**CONCEPTUAL MASTER  
WASTEWATER SYSTEM REPORT  
FOR  
SERENO CANYON**

**City of Scottsdale**  
**Water Resources Department**  
**Basis of Design Review Comments**

Project: Sereno Canyon

Date: January 27, 2006

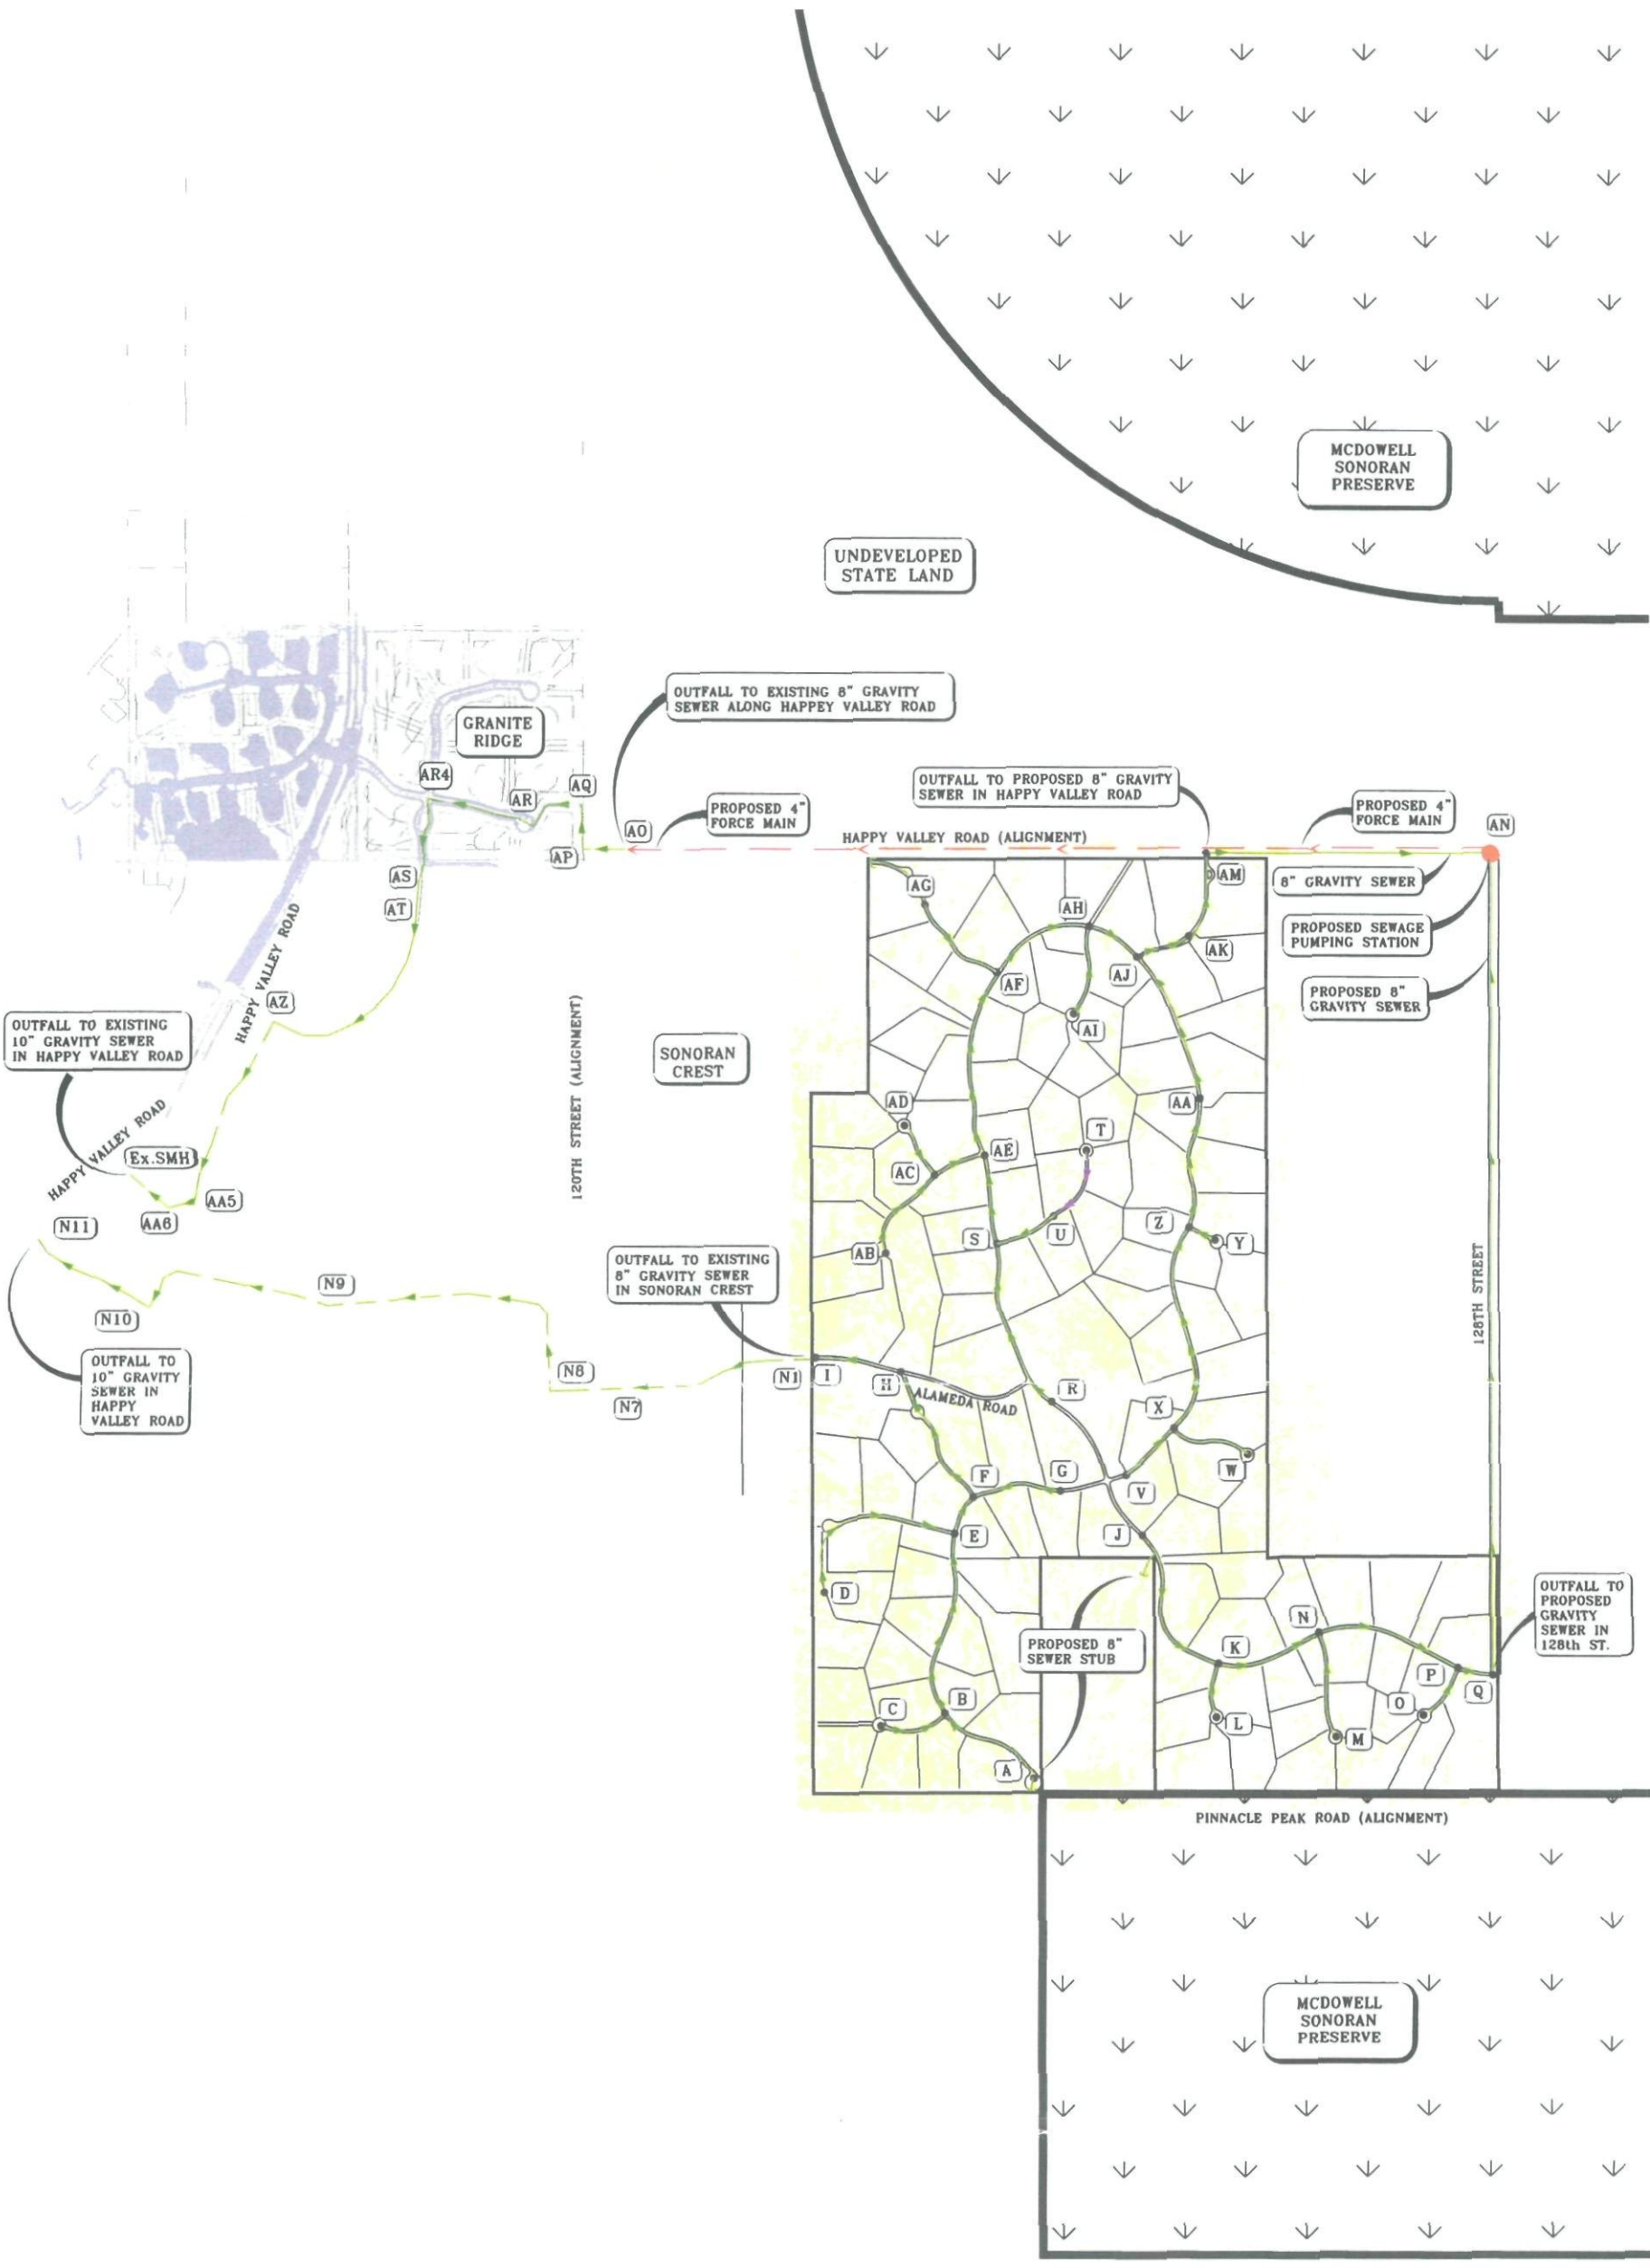
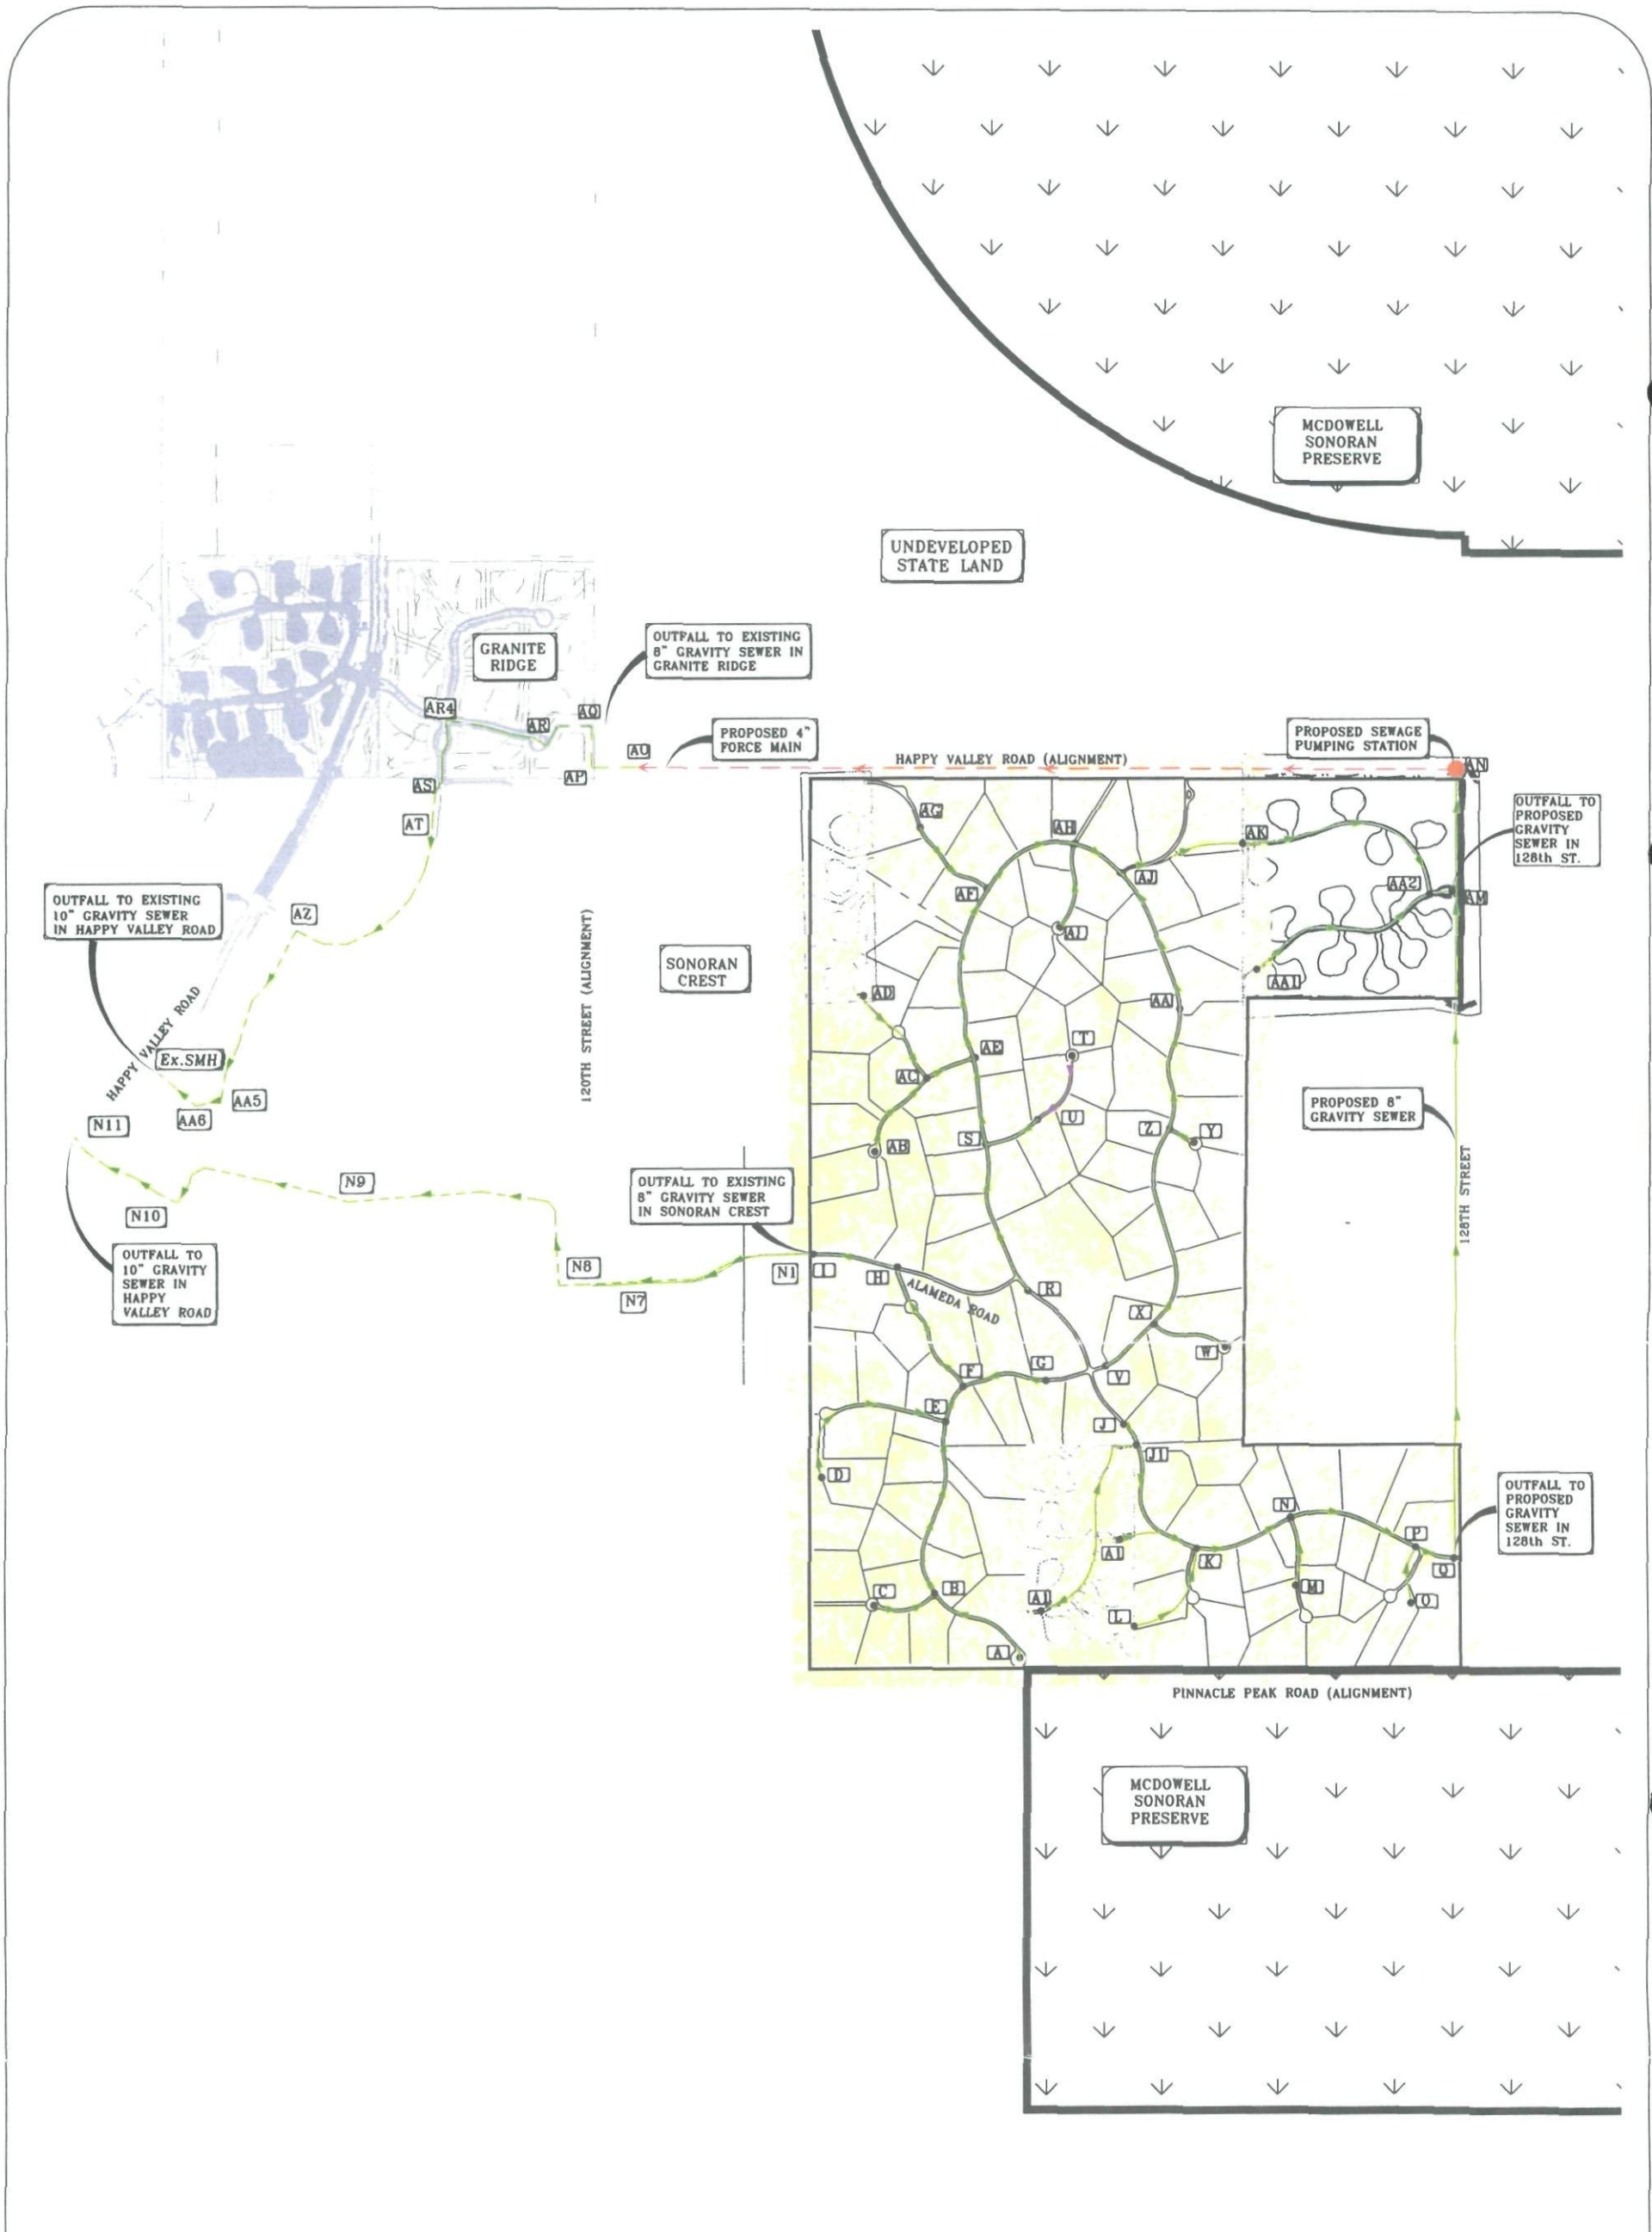
6. Any downstream capacity issues associated with the ultimate build out will be addressed in the City's master plan as a system deficiency.
7. I don't follow why there are options 1 and 2 associated with the ultimate build out.
8. There are some issues with the conceptual pump scenarios that we can resolve with the design report for the lift station.

**PLATE 4**

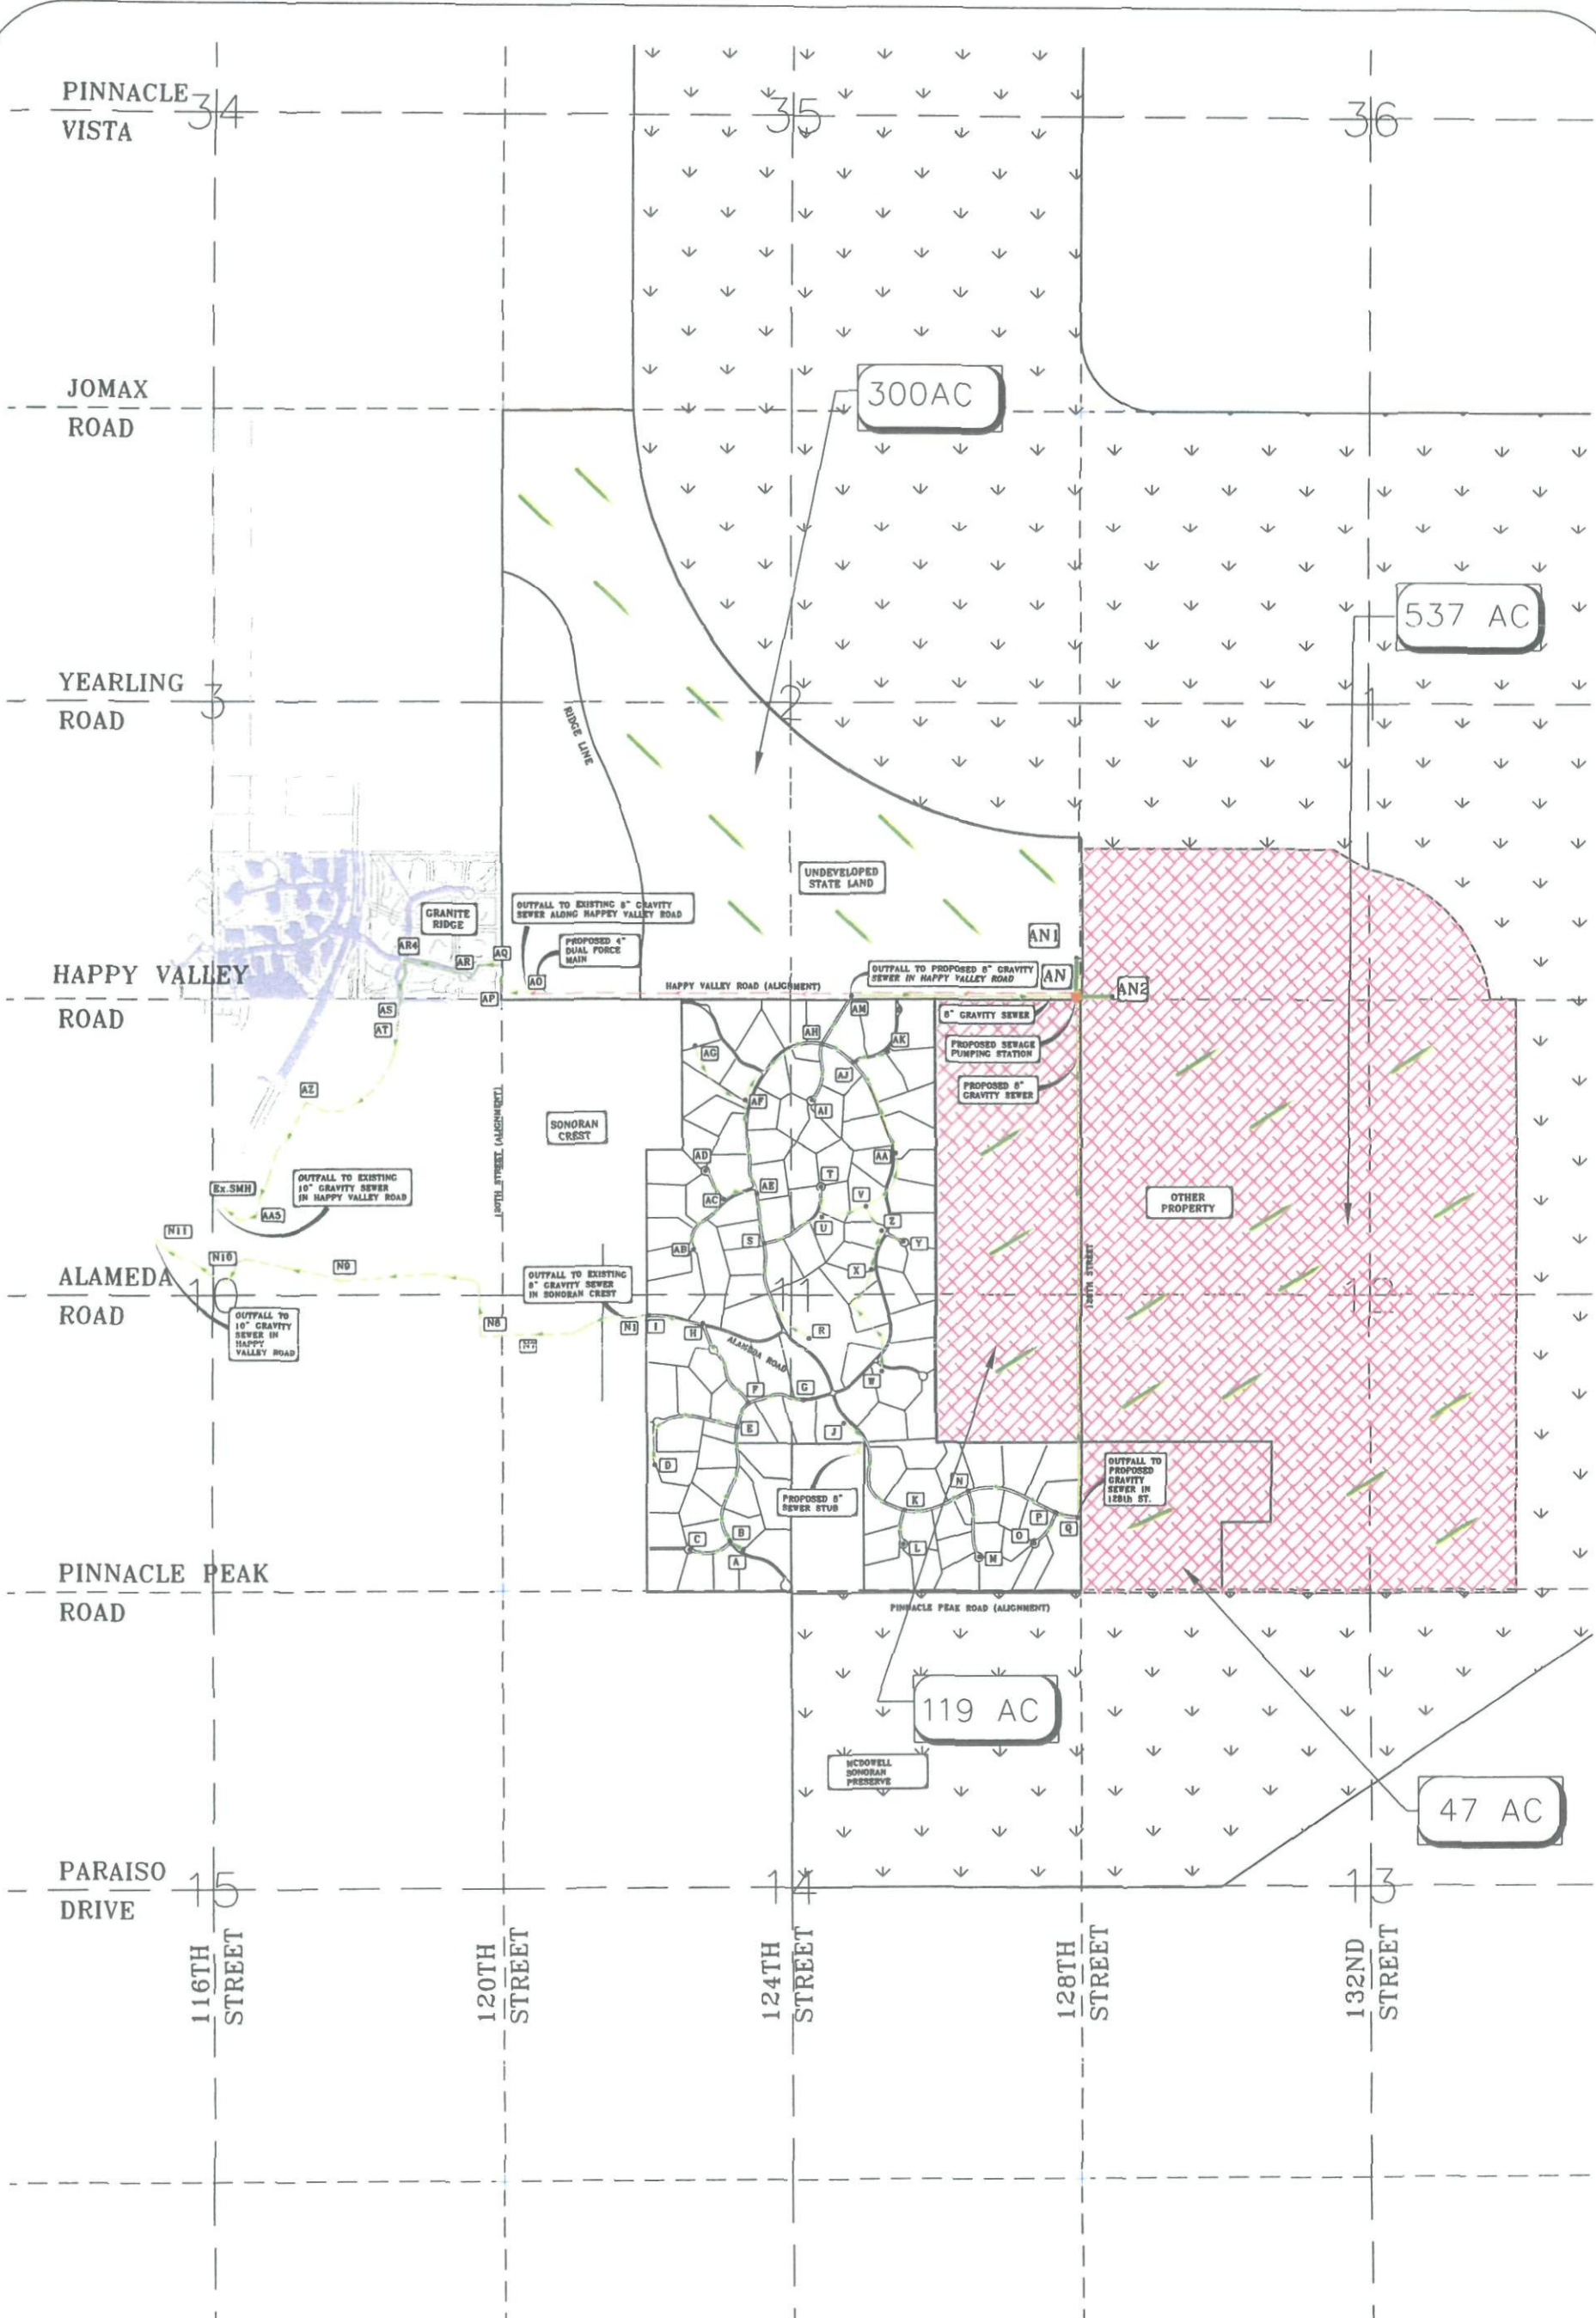
5. Plate 4, Option 1 is to include a line from the cul-de-sac off pipe 390 to the northwest property line for a future connection to the adjacent property. A stub to the property line shall be included off node J-310. A water line will be installed along the 128<sup>th</sup> Street frontage to this project.
